To:	Pitso Mokheti, Procurement
From:	Mfundi Songo, Senior Manager: Distribution Technology & Engineering
Copy:	Theunus Marais, Alkesh Ramprotal, Thomas Jacobs, Yvon Gombele, Niranjana Sentoo, Archibold Appoles
Date:	2023/02/10
Ref:	BESS_Eng-Exec_Memo_P1P4_MKHT-2
Subject:	Amendments to Melkhout BESS Project Scope

2.1 Amendments to the issued Draft version of BESS_Dx-SE-C20, Rev 3

The required amendments are indicated in Table 1 below which are reflected in BESS_Dx-SE-C20, Melkhout BESS Project Design, Supply and Install Scope of Work, Rev 4.

Figure 1: Environmental footprint coordinate markers

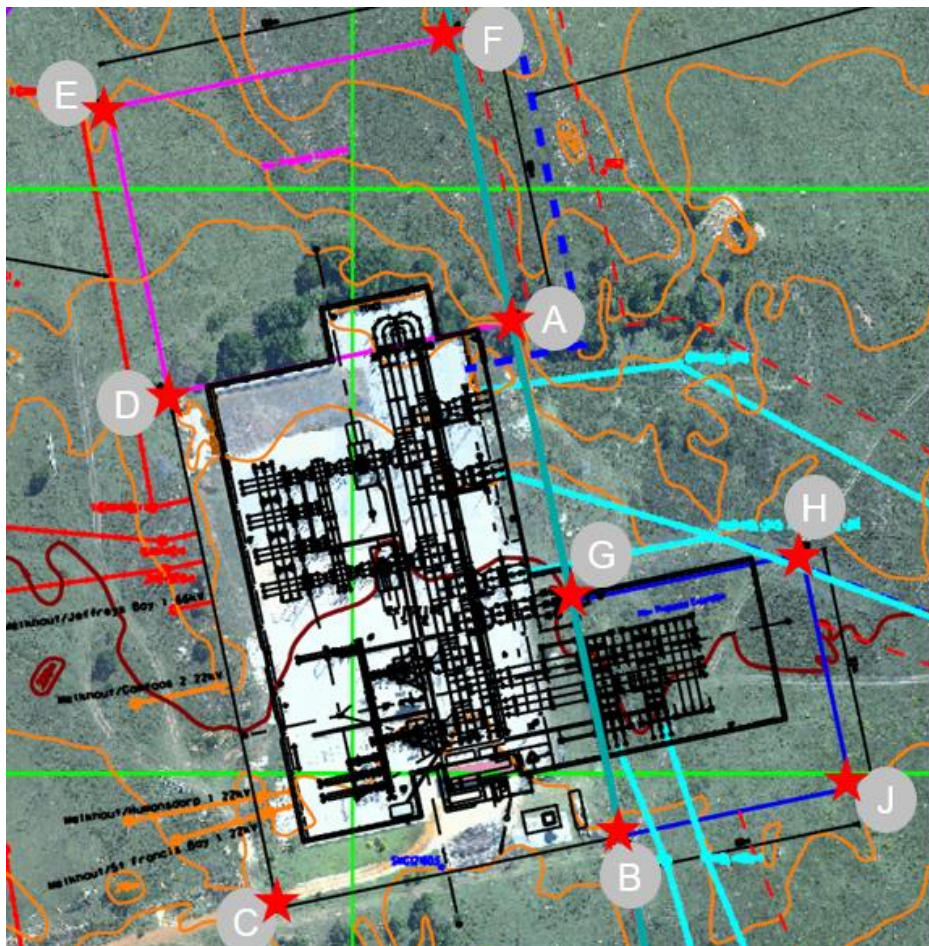
- f) The fence configuration shall be implemented as follows in relation to the respective markers as indicated in Figure 1 and Figure 2:
 - i) A-D-E-F will be the three tier fence for the BESS area.

- ii) A-D-C-B-J-H-G will be the single tier fence for the substation (with extension B-J-H-G).
 - iii) The existing substation palisade fence shall remain around the HV yard and be upgraded to the High Security fence for sections D-A, A-G and G-H.
